COUNCIL ASSESSMENT REPORT

Panel Reference	JRPP2016SYE088
DA Number	DA16/1035
LGA	Sutherland Shire
Proposed Development	Demolition of 9 dwellings and construction of a residential flat building development containing 101 units in 4 buildings over basement car parking
Street Address	29 – 41, 41A The Grand Parade and 48 Vermont Street Sutherland Lot 1 DP 105110, Lot 1 DP 365160, Lot 2 DP 365160, Lot B DP 369027, Lot 1 DP 560388, Lot 24 DP 612132, Lot 234 DP 633072, S/P 86262, Lot 1 S/P 86262, Lot 2 S/P 86262
Applicant/Owner	Benson McCormack (Architects) Pty Ltd
Date of DA lodgement	12 August 2016
Number of Submissions	Eighteen (18)
Recommendation	Approval
Regional Development Criteria (Schedule 4A of the EP&A Act)	General Development over \$20 million
List of all relevant s79C(1)(a) matters	<ul style="list-style-type: none"> • Sutherland Shire Local Environmental Plan 2015 (SSLEP 2015). • State Environmental Planning Policy (Building Sustainability Index: BASIX) 2004. • State Environmental Planning Policy (Infrastructure) 2007 • State Environmental Planning Policy No. 55- Remediation of Land (SEPP 55) • Greater Metropolitan Regional Environmental Plan No. 2- Georges River Catchment •

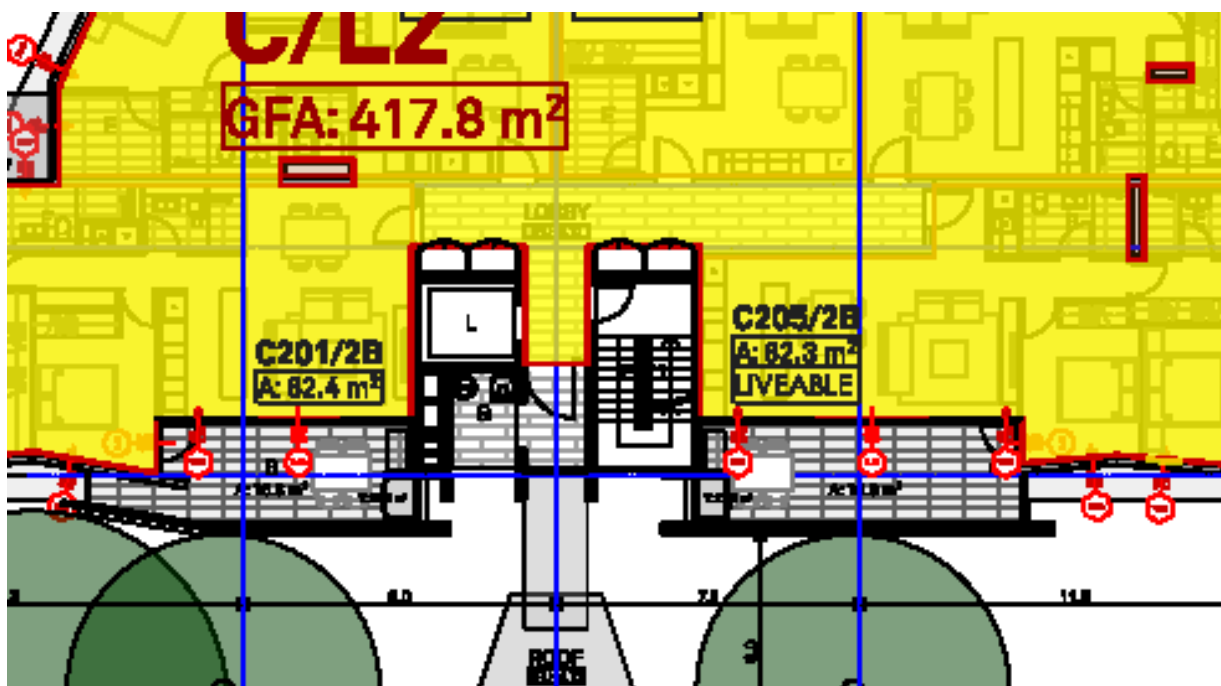
The proposed development fails to comply with the development standard for Floor Space Ratio (FSR). The site is located within "Area 12" on Council's Floor Space Ratio (FSR) Map. In accordance with the provisions of SSLEP2015, certain sites may receive an FSR bonus where a minimum amalgamated lot size greater than 2,500m² is achieved. The proposed development is permitted to exceed the maximum permitted FSR of 1.5:1 by up to 0.3:1. The maximum applicable FSR for the site is therefore 1.8:1.

The applicant indicates that the development complies with the development standard. Stairs on the upper level of the units within Building A have however been excluded from the calculation. Council counts stairs within apartments as they are not 'common', nor do they form of void (i.e. the area is occupied by stairs / vertical circulation on both levels). The applicant does not concur with this application of the development standard and asserts that the area of stairs should be classified as a void. The applicant has submitted a Clause 4.6 'for abundance of caution' addressing this deficiency and indicating that the development exceeds the development standard by 10m² (0.2% variation). The applicant written request in accordance with the requirements of clause 4.6 of SSLEP2015 is attached as **Appendix "G"**.

The applicant initially excluded the lobby areas within each Building from the calculation. In response to Council's concerns the applicant has amended the development scheme and provided a reduction in GFA. The revised floor plan has however externalised part of the lobby areas within Buildings C and D to form enlarged waste areas (approx 9.5m² each, or 95m² over Levels 2 – 6 of Buildings C and D).

The location of these waste rooms is anticipated to give rise to adverse impacts due to the prominent visual location of the site / development adjoining The Grand Parade and Sutherland Overpass as well as the close proximity to adjoining resident balconies. The connection of the roofed entry structures from the street also creates a security concern and climbable zone (to waste room and lobby areas) and increases the possibility of pest and vermin access. Further, daylight and visual outlook from the lobbies is removed resulting in a poor urban and amenity outcome for future residents. Council recommends that these areas be enclosed or provided with substantial screening which in turn will result in an increase in floor space approximately 95m² across the development.

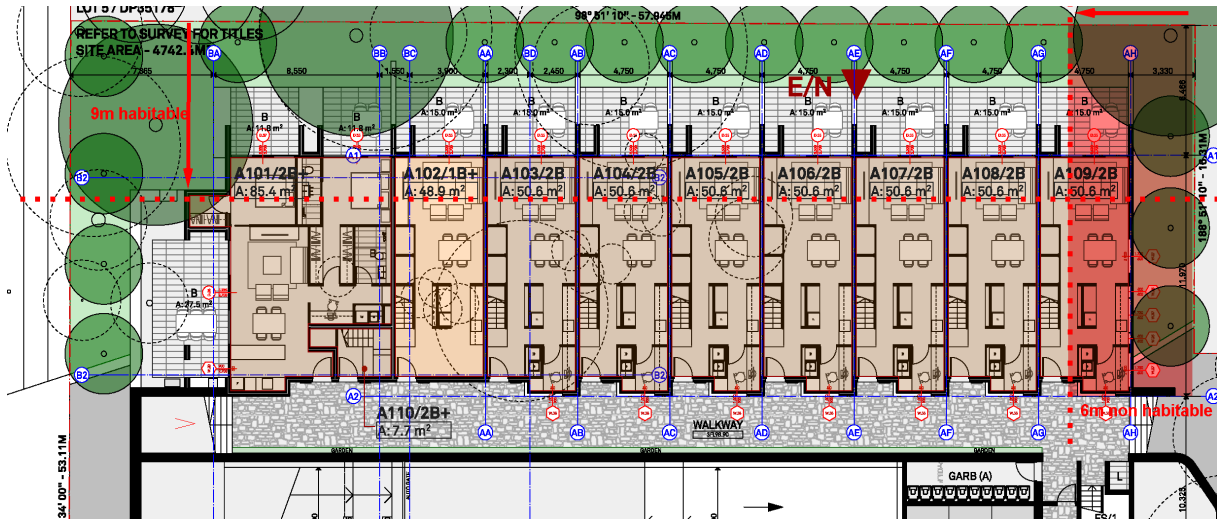
Whether or not these areas are fully enclosed, they add to the apparent bulk of the building and within the external face of the buildings outer walls.

The development benefits from an FSR bonus for amalgamating land with an area greater than 2,500m². Council is not supportive of any variation to the FSR development standard, particularly in light of the bonus, and the nature of the land which abruptly transitions from high density to low density to the north. As discussed further in this report the most sensible point for a reduction in GFA to occur is at the northern portion of the Vermont Street Building B (upper level units), and eastern portion of Building A where the building exceeds the height and setback limits and where the development is closest to the low density residential zone. A transition to a lower scale is most appropriate at these locations and the design recommendations are anticipated to reinforce and satisfy the objectives of the development standard and zone R4 and result in a compliant FSR development scheme.

In conclusion the variation to the FSR development standard fails to satisfy all relevant parts of clause 4.6 and therefore the variation cannot be supported. The applicants written request in accordance with the requirements of clause 4.6 of SSLEP2015 inadequately demonstrates that compliance with the FSR development standard in is unreasonable or unnecessary in the circumstances of the case. It also fails to demonstrate sufficient environmental planning grounds to justify varying this development standard. There is a significant public benefit to maintain the development standard in the circumstances of this particular case. A condition requiring the building mass to be reduced is recommended as detailed in the discussion below.

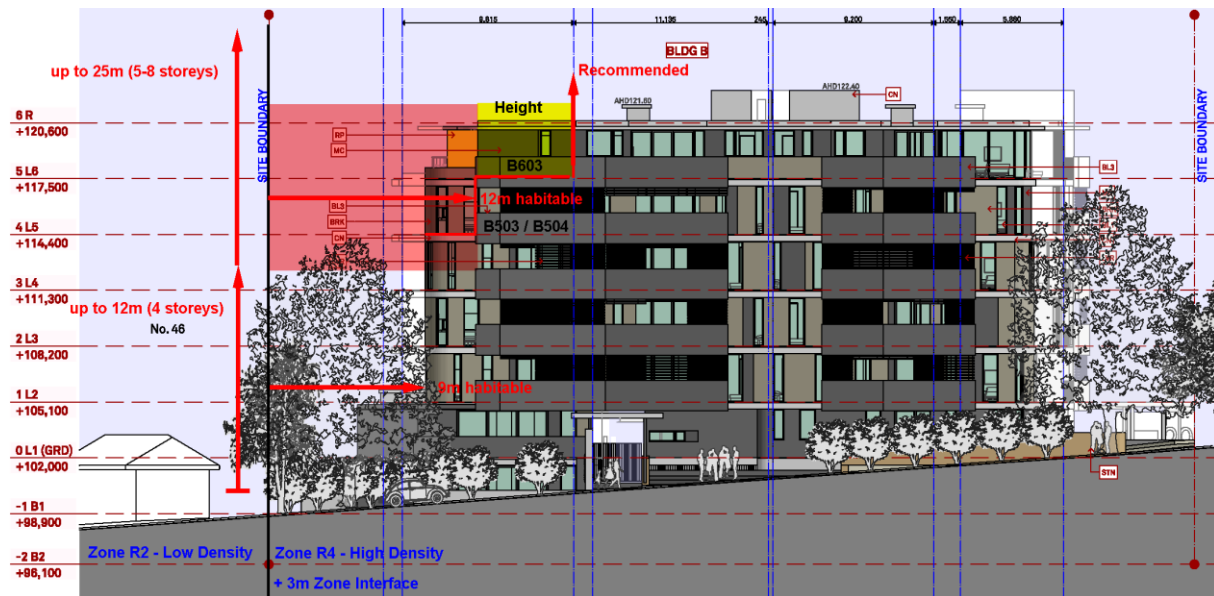
The northern portion of Building B (Unit B603) on Vermont Street exceeds the height standard. A minimum 7.5m setback to non-habitable elevations and a 12m setback for habitable elevations for development between 12m to 25m in height (5-8 storeys) is required at the northern zone interface. The proposal is largely consistent with the setback controls however, the built form makes an abrupt transition from Building A (2 storeys) to Building B (6-7 storeys) where there is an associated height non compliance. The eastern side of Vermont Street is characterised by low density 2 storey development. A greater transition to a lower scale at this edge 'over and above' the minimum design criteria established in the ADG is recommended to ensure the development responds to its zone interface and achieves reasonable levels of external and internal amenity and streetscape presentation. The increased setback and articulation in built form is proposed to be deployed at the upper Level 6 (Unit B603) rather than being provided at Level 5 below which is the most appropriate location where there are habitable elements in the building elevation (kitchen windows). Realising the full development potential particularly at a zone interface is difficult when considering the likely future scale and character of development on neighbouring land.

Variation to the lowest 2 storeys (Building A) is recommended (as previously discussed) and the remaining minor elements of non compliance are considered to be acceptable subject to suitable conditions of development consent including the provision of a planter edge where the upper level balcony encroaches. To overcome the above concerns (including a reduction in FSR) and to ensure the development adequately responds to the interface with the adjoining low density zone, the following design changes are recommended:

- Delete Level 5 Units B503 and B504 and the area to take the form of Unit B603 above (i.e. setback 12m from northern boundary).

- Delete Level 6 Unit B603. The resulting external space be provided as open terrace to units B602 and B604 to a maximum depth of 2.5m, with no roof form (other than standard eave) projecting over the terrace external space and a planter edge. Enlarge Unit B604 to the north to align with the northern alignment of unit B602.
